National Electrical Manufacturers Association

March 27, 2023

Re: Energy Conservation Program: Energy Conservation Standards for Distribution Transformers, docket
EERE-2019-BT-STD-0018

Figure 1: Trip curves with low-voltage distribution transformer inrush, Schneider Electric.

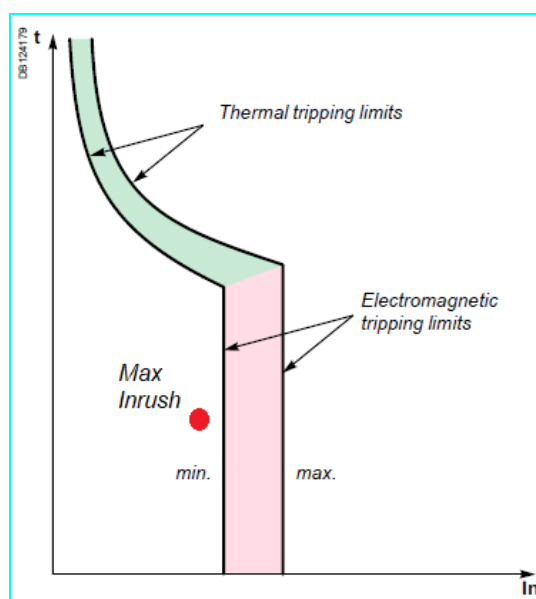
20) DOE requests comment on the interaction of inrush current and data center distribution transformer design. Specifically, DOE seeks information regarding: (1) the range of inrush current limit values in use in data center distribution transformers; (2) any challenges in meeting such inrush current limit values when using amorphous electrical steel in the core; (3) whether using amorphous electrical steel inherently increases inrush current, and why; (4) how the (magnetic) remanence of grain-oriented electrical steel compares to that of amorphous steel; and (5) other strategies or technologies than distribution transformer design which could be used to limit inrush current and the respective costs of those measures.

The maximum inrush must be designed to be on the left of the over current trip curve, allowing the device to continue to function even when seeing maximum inrush from the transformers.

Addressing inrush current that may cause nuisance tripping may be accomplished via other components:

- Inserting resistance during energization of a transformer, also known as soft start, needs to be incorporated in the static transfer switch (STS) system for data center applications but would need to be added into the breaker or fusible safety switch on other applications.

- Coordinating the primary overcurrent protection trip curves to align with the maximum inrush current from the transformer by:
 - Employing electronic breakers with adjustable trip settings, increasing the costs for these transformers by obtain the highest price point device for protection; or,
 - Designing the electrical system with the maximum allowed primary overcurrent protective device permitted by NFPA 70, National Electrical Code. This method will also require transformer secondary overcurrent protection into the system design on LVDT units to properly protect the entire system, adding cost by adding components to the system not required today.
